ADDENDUM NO. 3

**EISENHOWER ELEMENTARY SCHOOL ADDITIONS, RENOVATIONS,
AND RELATED WORK
Crown Point, IN 46307**

Addendum Three (AD.03) to the drawings and specifications prepared by Gibraltar Design for **Eisenhower Elementary School – Additions, Renovations and Related Work** for Crown Point Community School Corporation, Crown Point, Indiana.

DRAWING
UNIT "A" ARCHITECTURAL
FIRST FLOOR DEMOLITION
PLAN

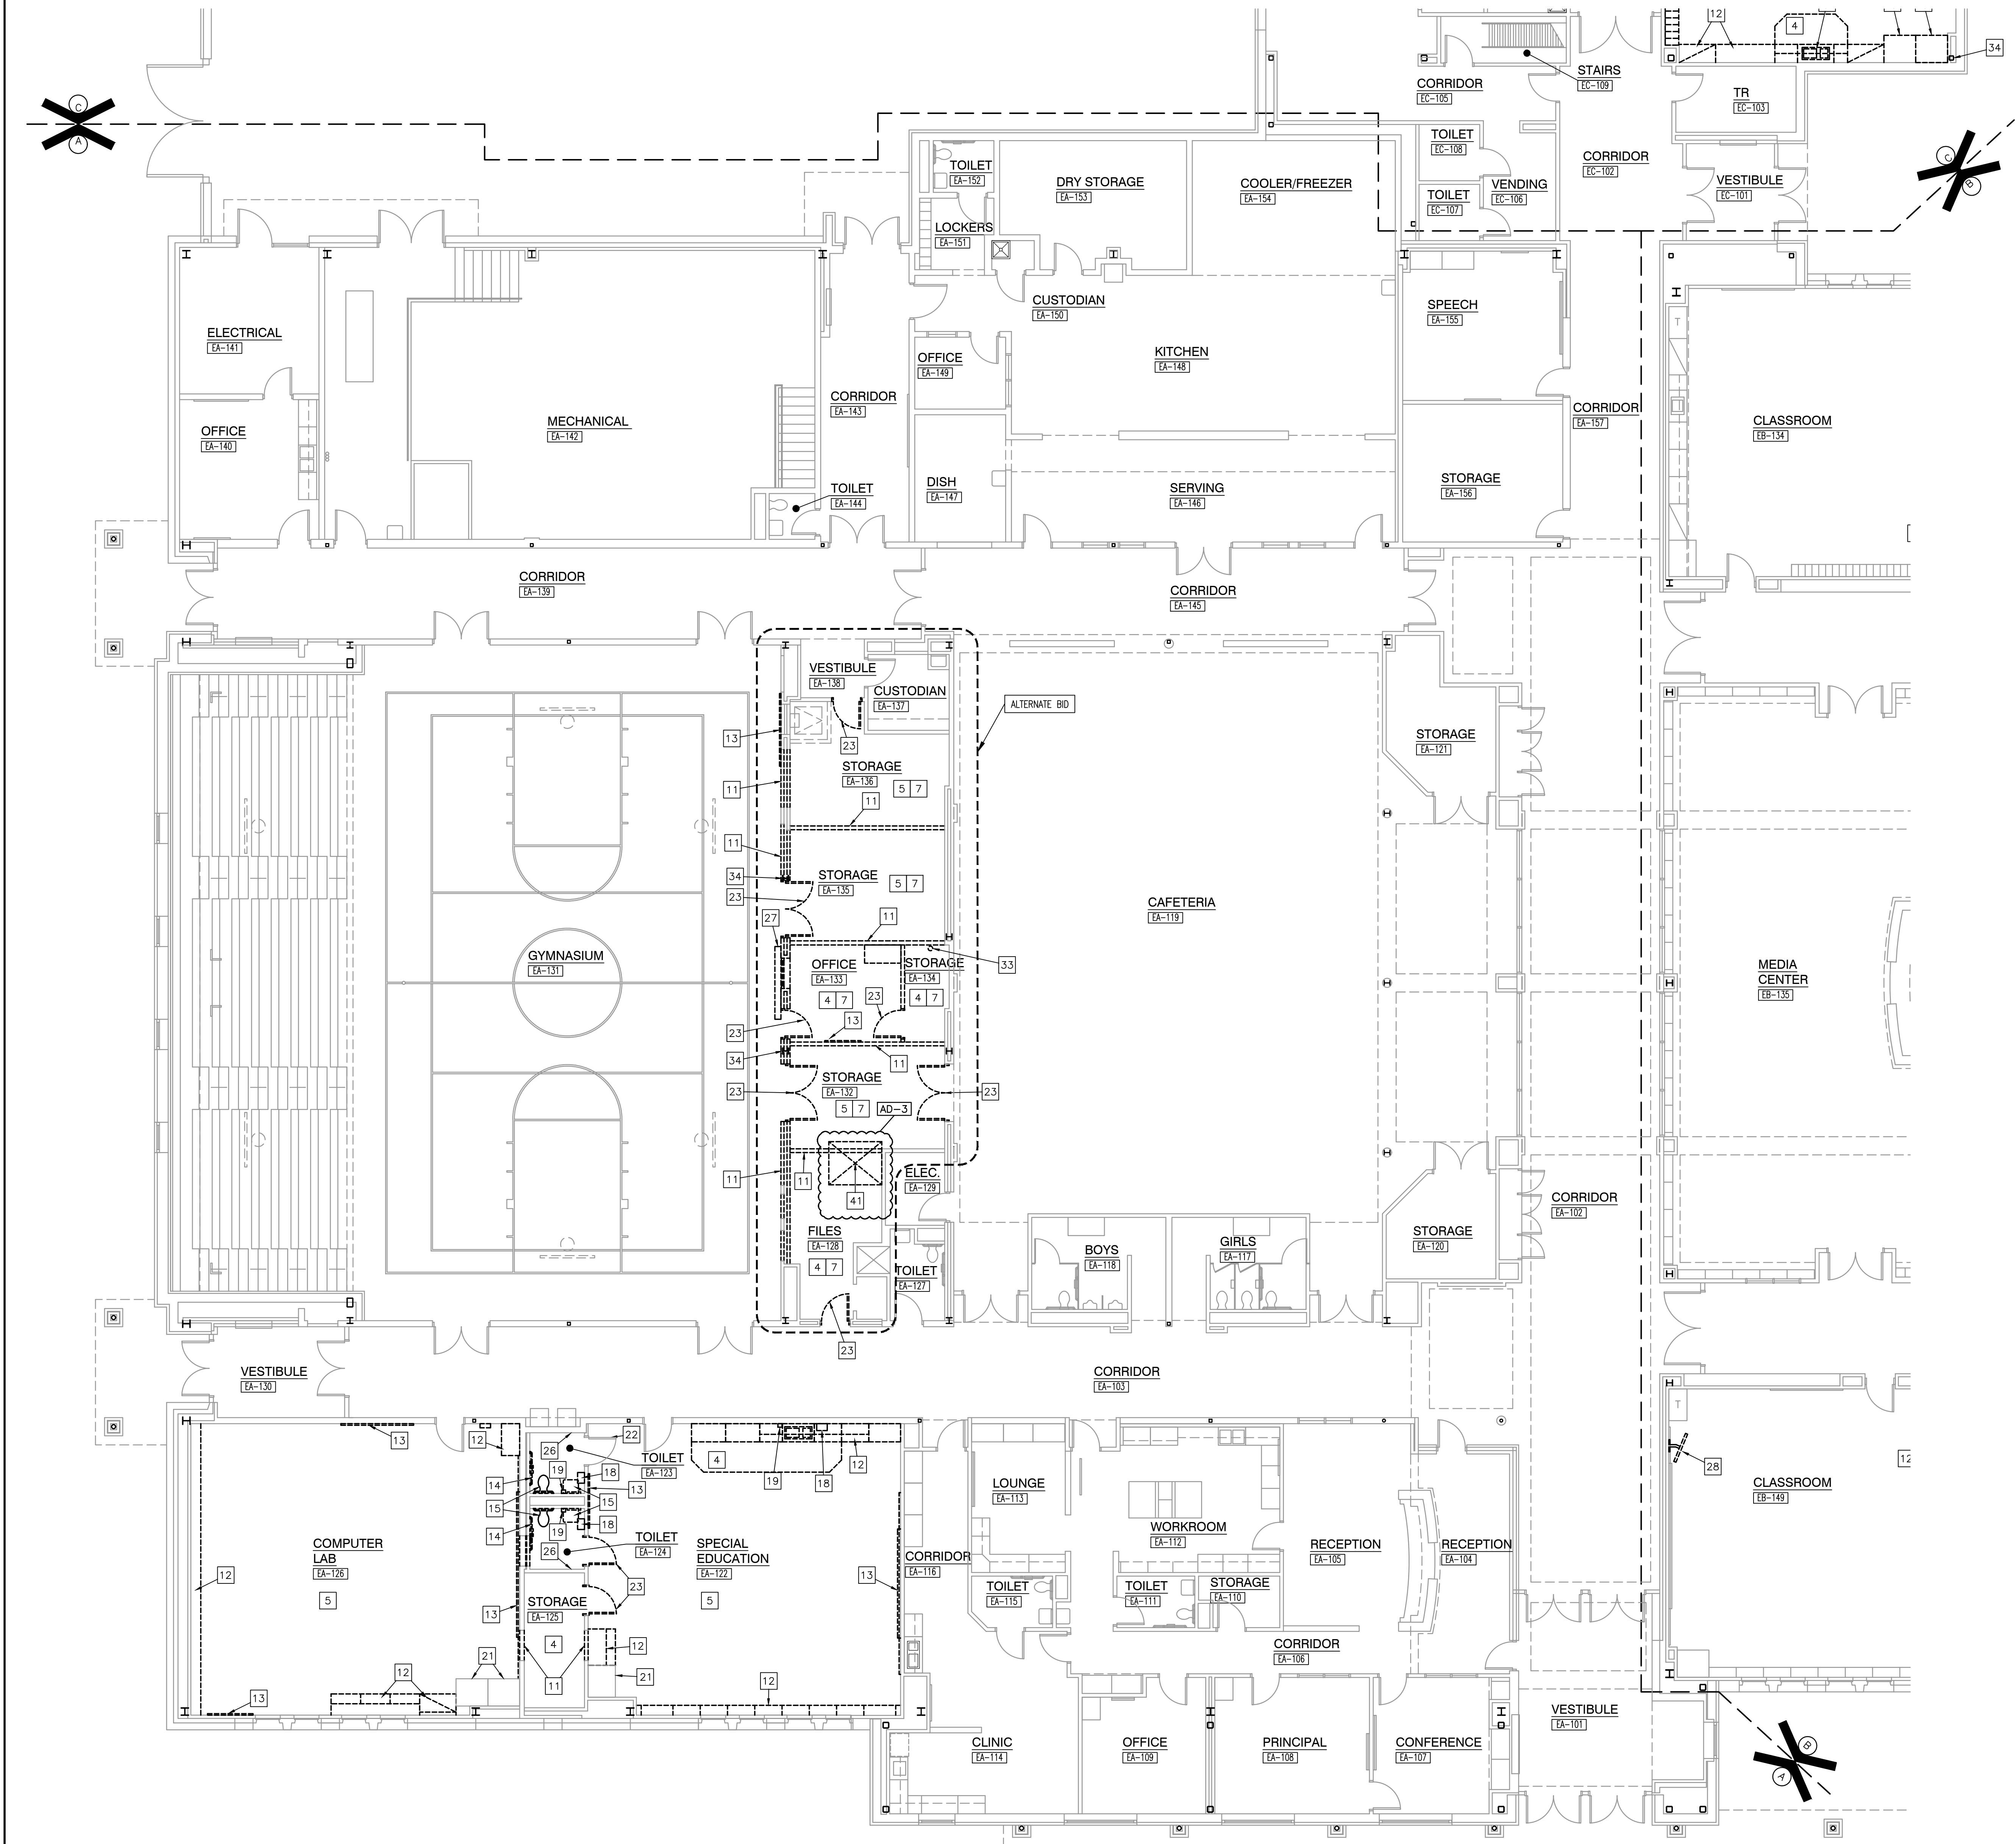
1. **Sheet AD101**
 - A. Refer to revised, full-size drawing, included in this Addendum for the following revision:
 1. Add note regarding removal of existing concrete slab for installation of wheelchair lift.

- REMOVE EIFS SOFFIT AND FASCIA WHERE APPLICABLE AS REQUIRED FOR NEW CONSTRUCTION.
- REMOVE BUILT IN WOOD BENCH IN ITS ENTIRETY.
- CUT AND REMOVE CONCRETE SLAB AS REQUIRED FOR LIFT INSTALLATION.
